72+COLLINS DEVELOPMENT

CITY OF MIAMI BEACH
DESIGN REVIEW BOARD

MARCH 2, 2021

72 COLLINS HOTEL & CONDOMINIUM
MIAMI BEACH, FL

NORTH BUILDING ELEVATION - PHASE 1

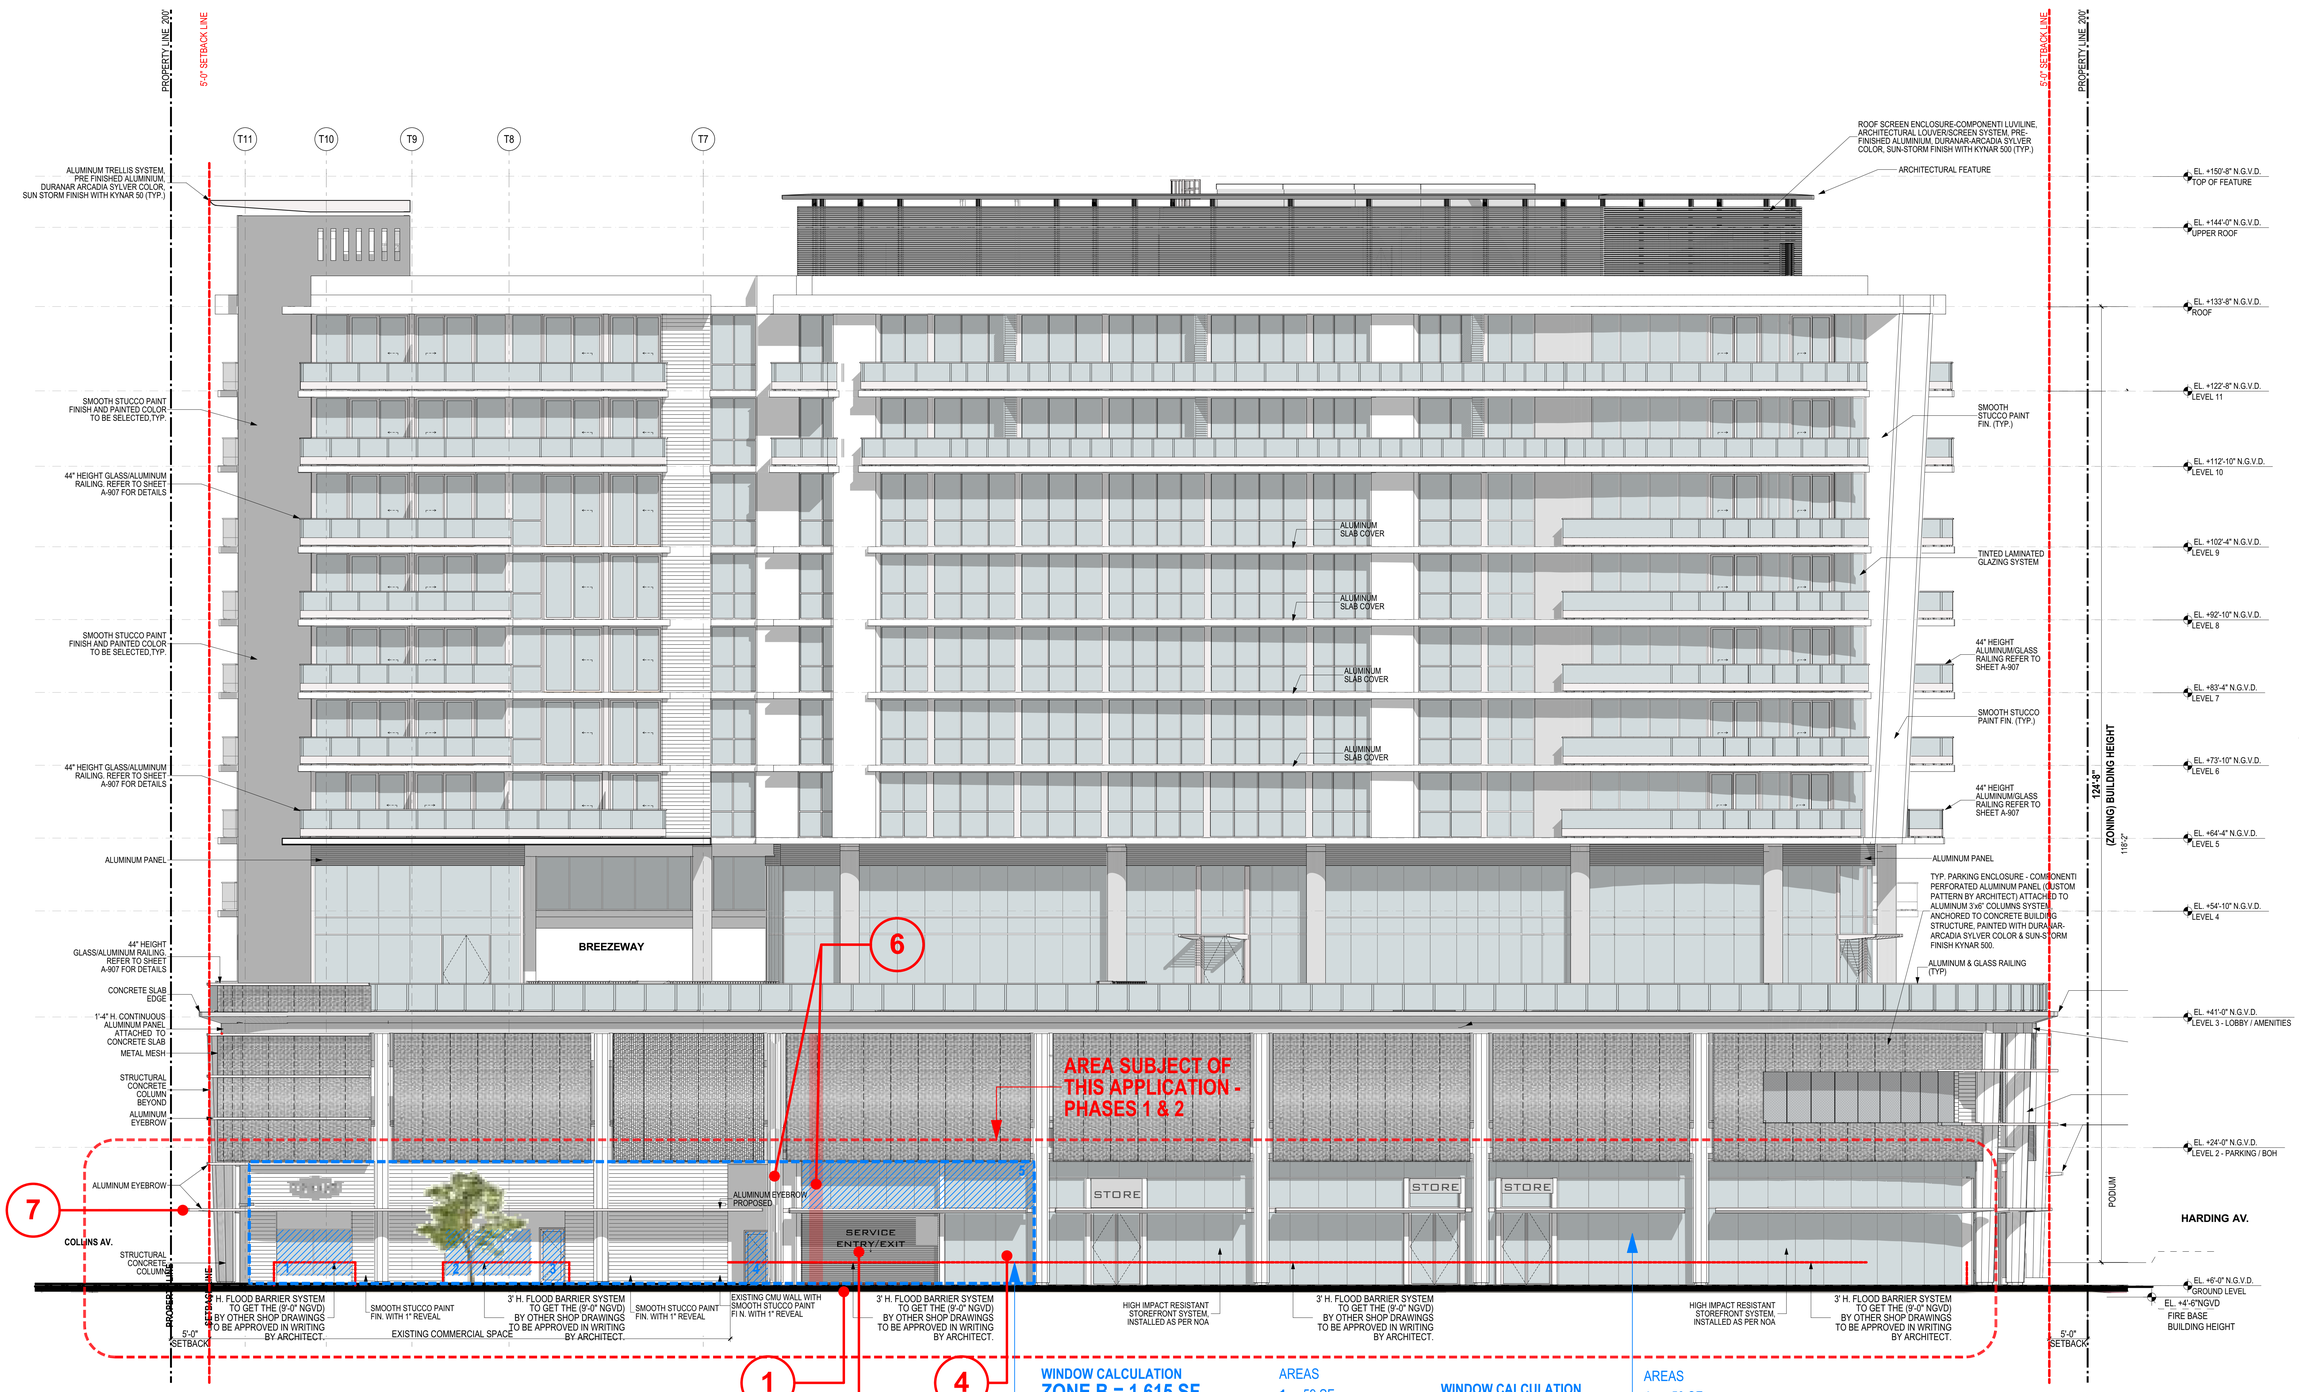
PROPOSED MODIFICATIONS ON PHASE 1

1.	NEW CURB CUT
2.	NEW ROLL-UP GATE - ENTRY TO ADDITIONAL PARKING
3.	Not used
4.	DISPLAY WINDOW
5.	Not used
6.	COLUMN RELOCATION
7.	ALUMINUM AWNING/EYEBROW EXTENDED TO MATCH FOOTPRINT OF EXISTING CONSTRUCTED AWNING

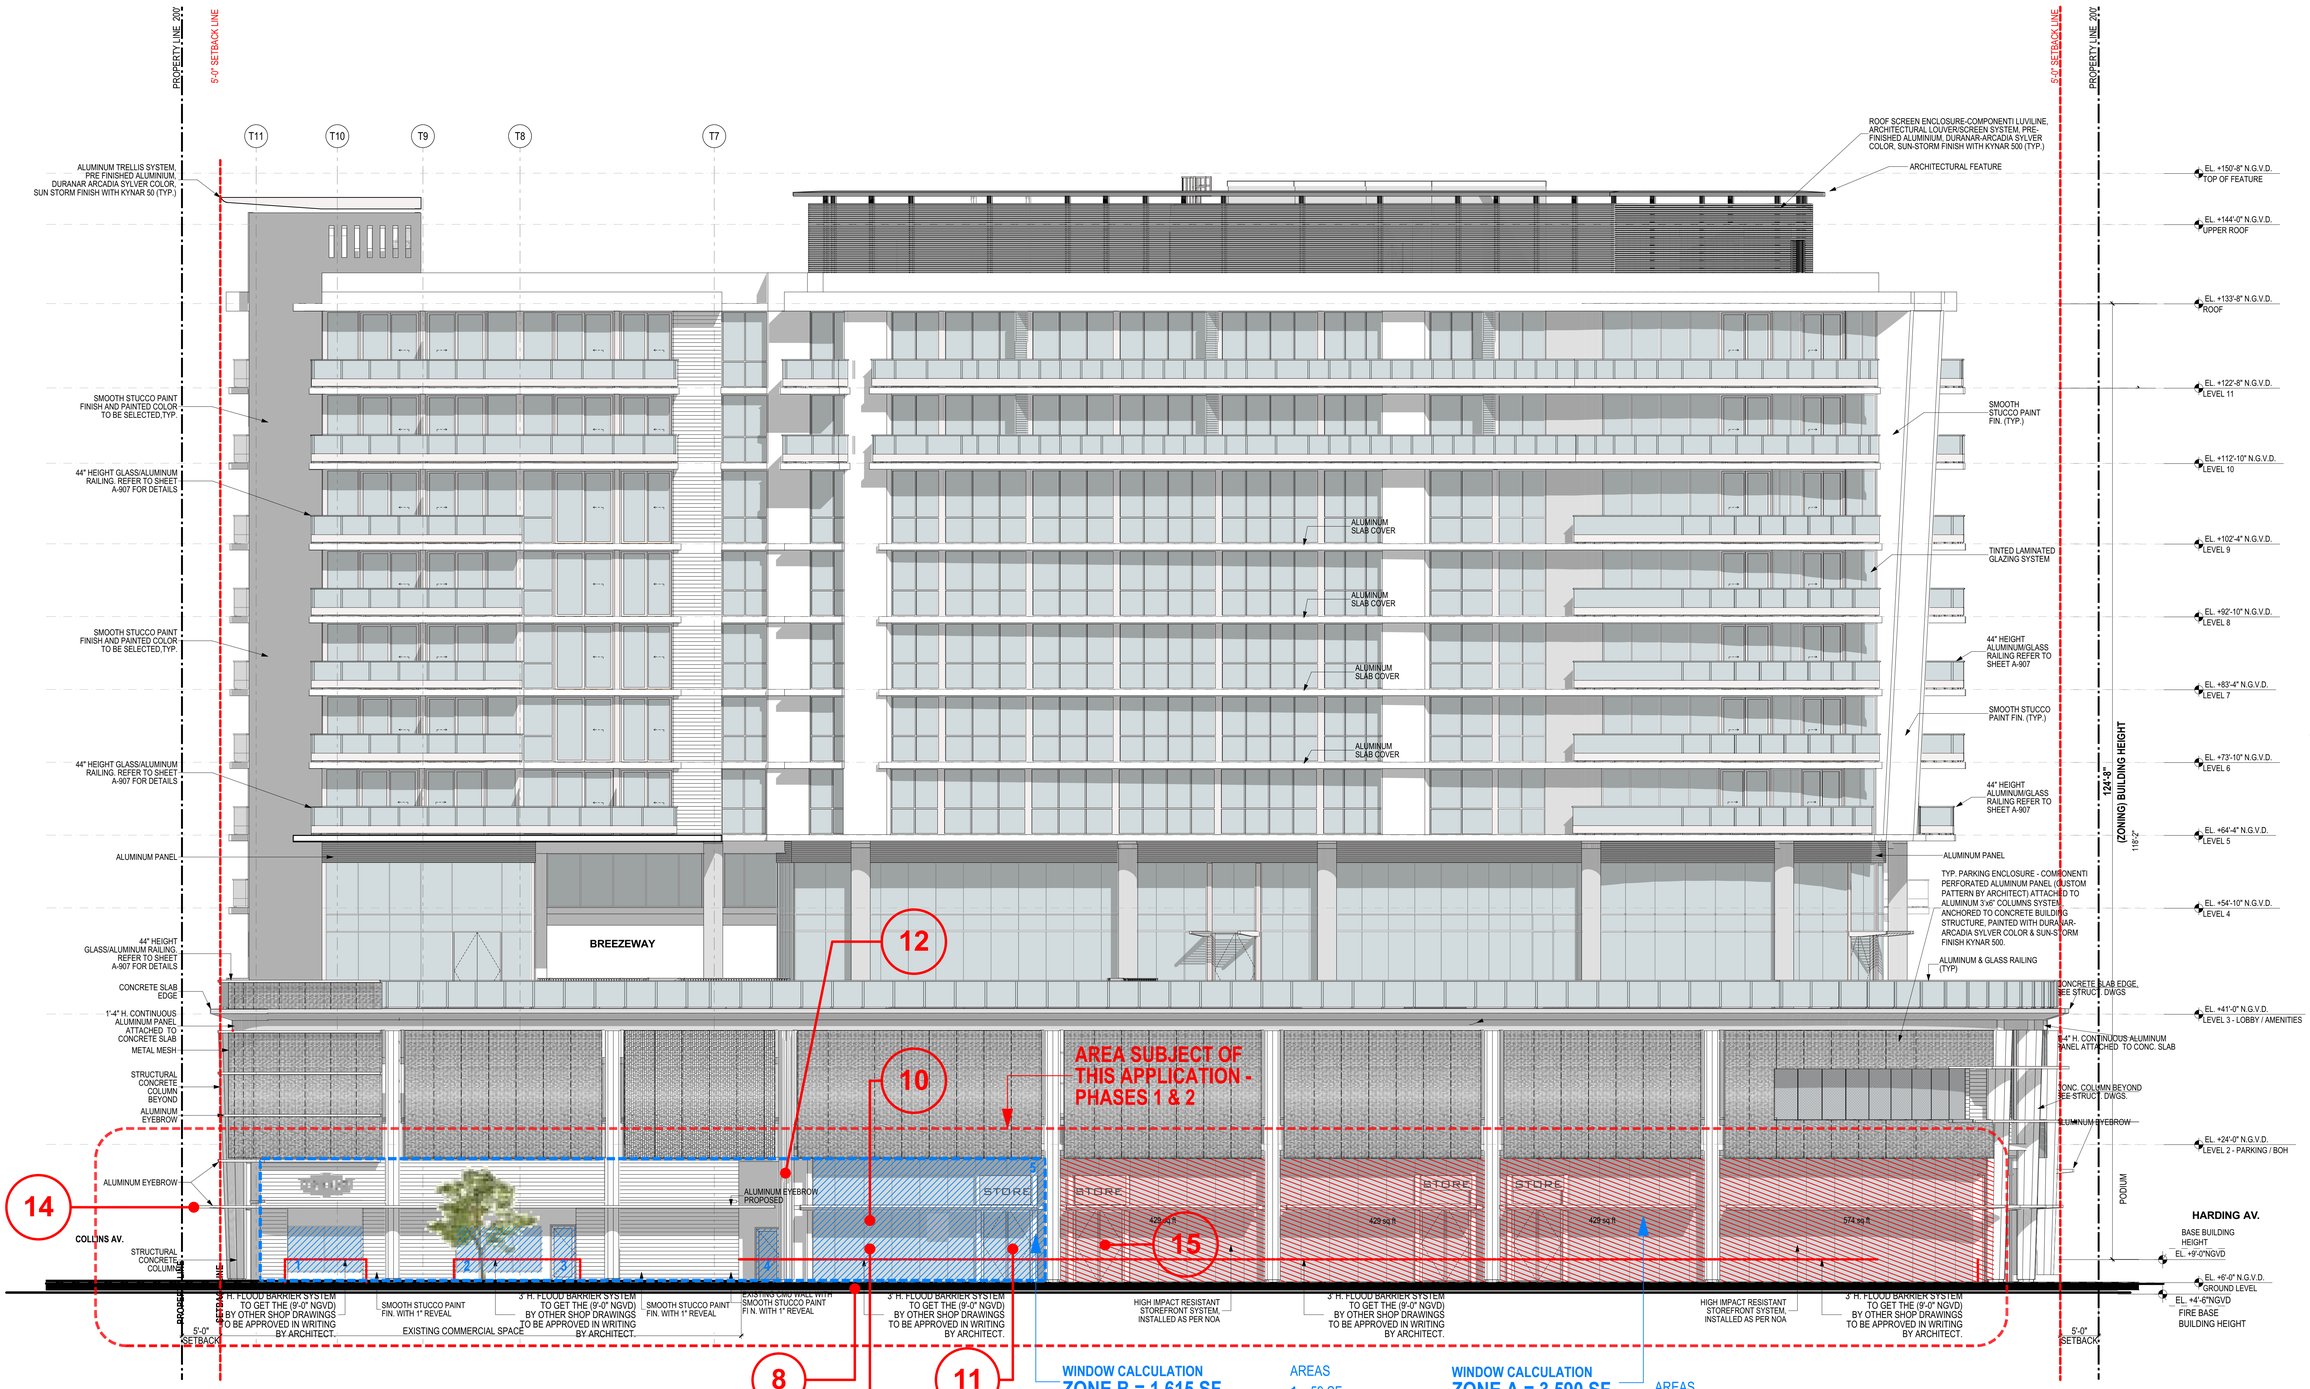
PROPOSED MODIFICATIONS ON PHASE 2

8.	CLOSING OF CURB CUT
9.	NEW LANDSCAPE AND HARDSCAPE TO MATCH ADJACENT AREAS
10.	REPLACE GATE WITH STOREFRONT
11.	INSTALL NEW RETAIL DOOR
12.	COLUMN REMAIN IN THIS LOCATION
13.	COMPLETION OF RETAIL SPACE
14.	ALUMINUM AWNING/EYEBROW DIMENSIONS REMAIN
15.	RELOCATION RETAIL DOOR
